NHTSA Safety Recall 23V-627

SUBJECT: Campaign # 176 – Travato Awning Deployment

Travato Gen 1 Awning Rework: Recall #176 Work Instruction Rev B Addendum

Travato Gen 1/2 Awning Rework: Recall #176 Work Instruction Addendum

Image 2
Gen 1 Harness

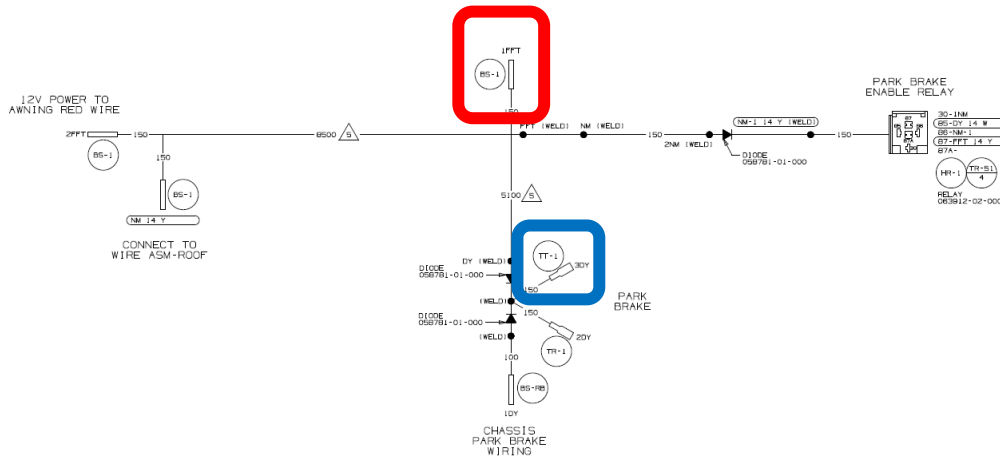
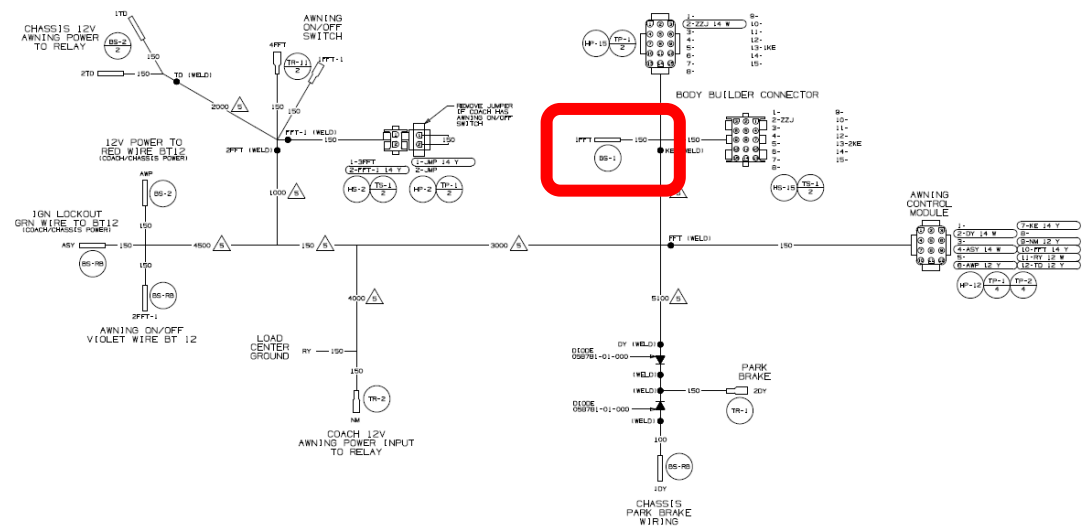
- a. **Note:** With this change, the FFT splice on the new harness will not be used. See Image 2 and 3 red boxes, Tape up this terminal.
3. In “Step 2 – Installing New Harness – Gen 1” the existing instruction packet states to “Follow Step 2H – Route to Roof (awning connection circuits FFT and NM)”. This step is unnecessary for Gen 1 Coaches as FFT and NM will either go to the awning switch or the 12V distribution panel as directed in Step 3A. Disregard step 2H for Gen 1 Coaches.

Image 2
Gen 1 Harness

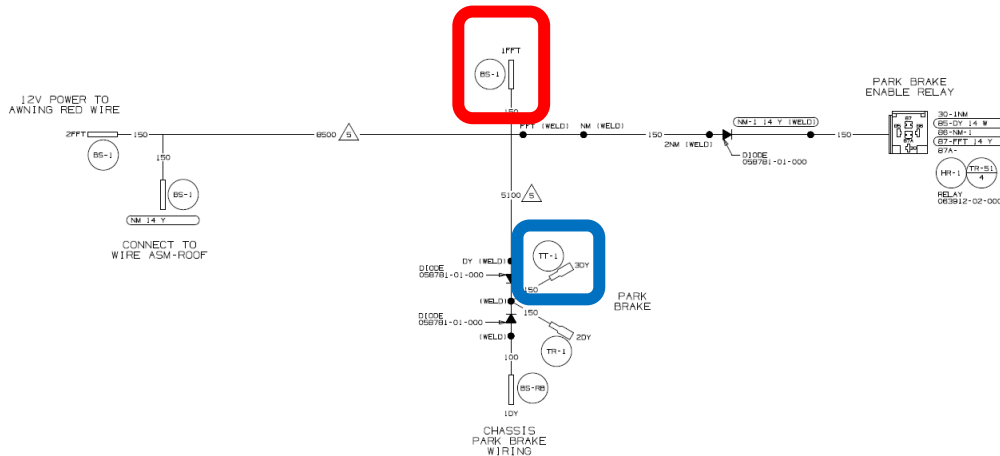
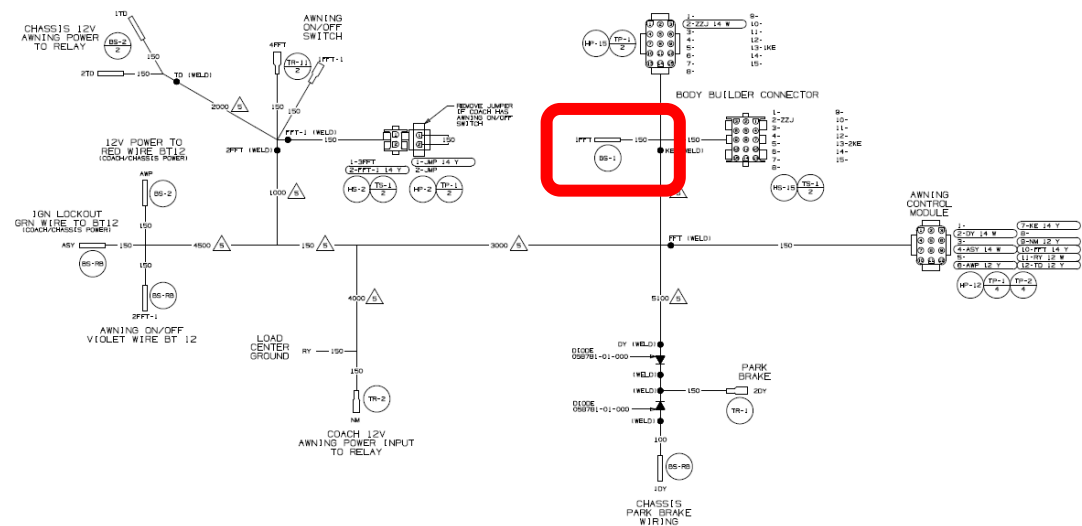
- a. **Note:** With this change, the FFT splice on the new harness will not be used. See Image 2 and 3 red boxes, Tape up this terminal.
3. In “Step 2 – Installing New Harness – Gen 1” the existing instruction packet states to “Follow Step 2H – Route to Roof (awning connection circuits FFT and NM)”. This step is unnecessary for Gen 1 Coaches as FFT and NM will either go to the awning switch or the 12V distribution panel as directed in Step 3A. Disregard step 2H for Gen 1 Coaches.
